# Technical Bulletin

<b>NP01</b>	<b>TB0005-2016</b>	<b>Élan Motorsports Technologies</b>	
<b>From:</b>	<b>Robert Lindsey – Project Engineer, NP01</b>		
<b>Subject:</b>	<b>Upright Improvement</b>	<b>Date:</b>	<b>3 Feb 2016</b>

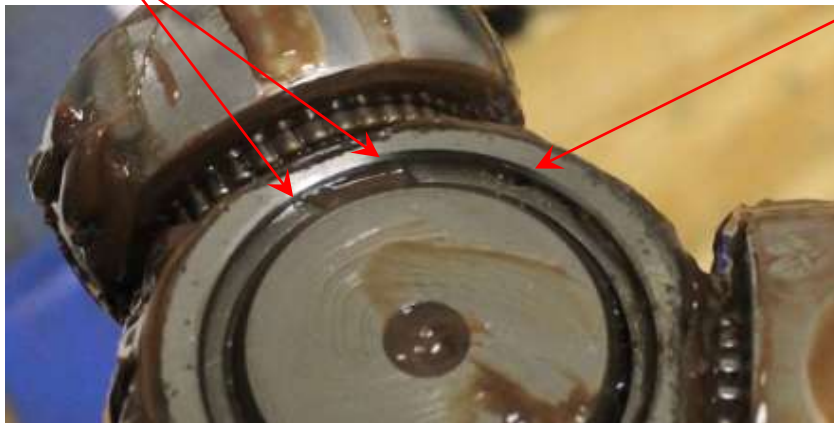
- Remove inner tripod retainer ring (cap head bolts only, not countersink)
